TOWN OF CHATHAM

TRAP DOCK RECONSTRUCTION Chatham, MA

ADDENDUM NO. 3

October 18, 2019

Trap Dock Reconstruction
Chatham, MA
ELECTRICAL
ONE LINE DIAGRAM

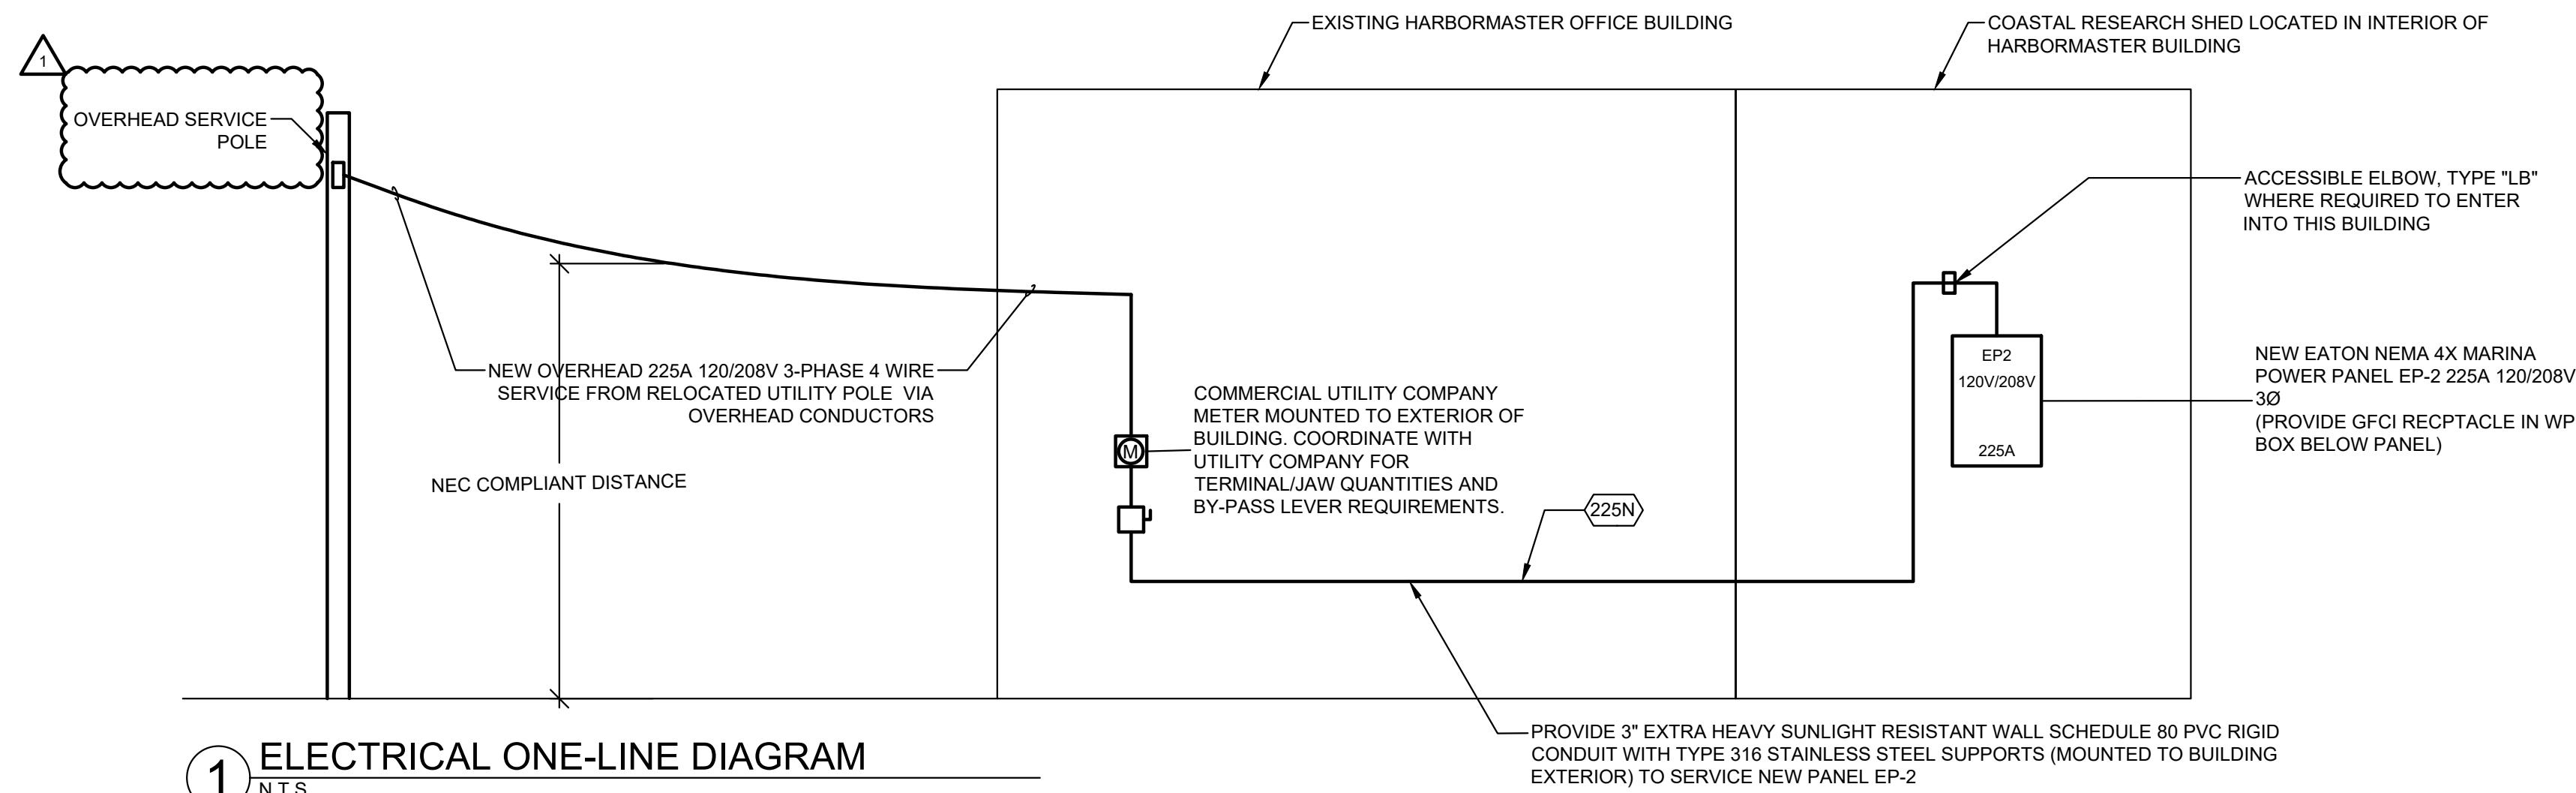
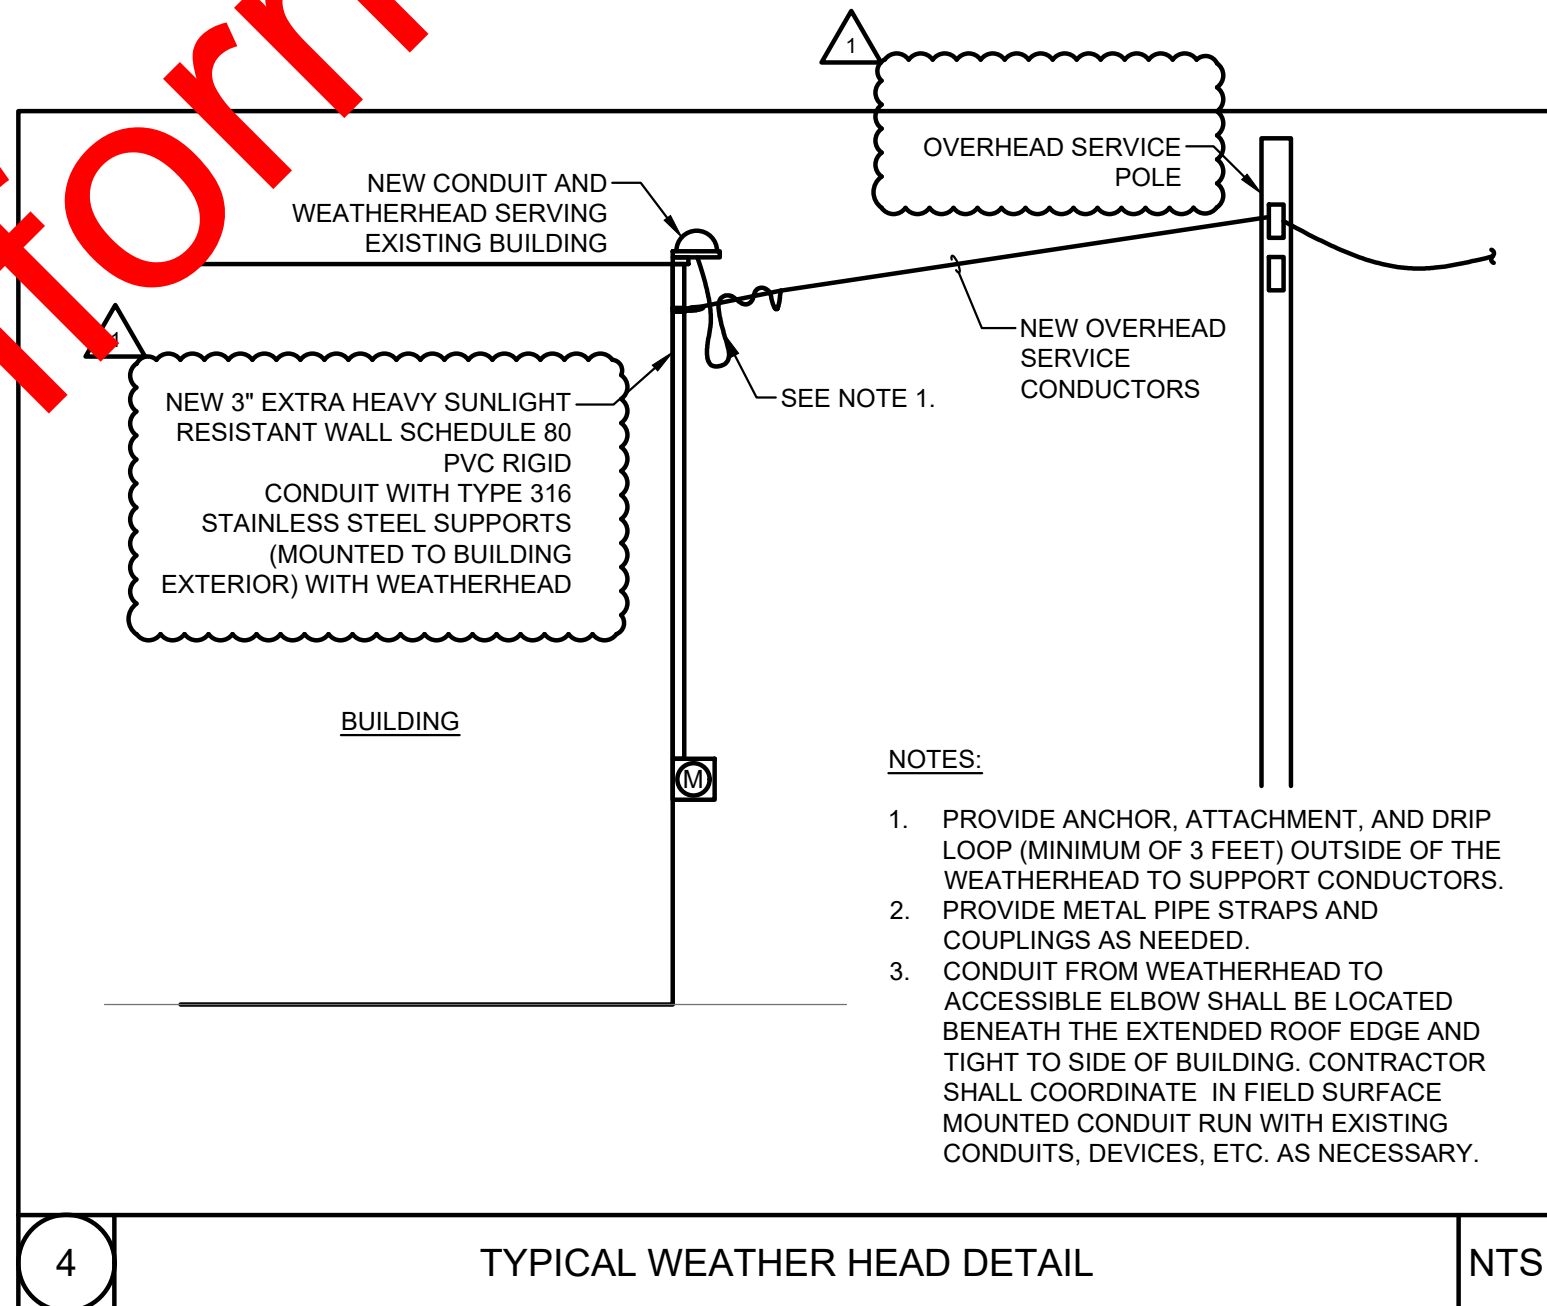
- c. On Sheet #21 using the photo of the building, where is the new meter socket intended to be located?
The proposed meter location is shown on the picture on sheet #21. The final location will be determined in the field during construction by Eversource. The intended location will be on the same side of the building as the existing services.

Sheet E-05

Replaced in its entirety. Changes are clouded to reflect existing pole to remain, and meter location to be coordinated with Eversource.
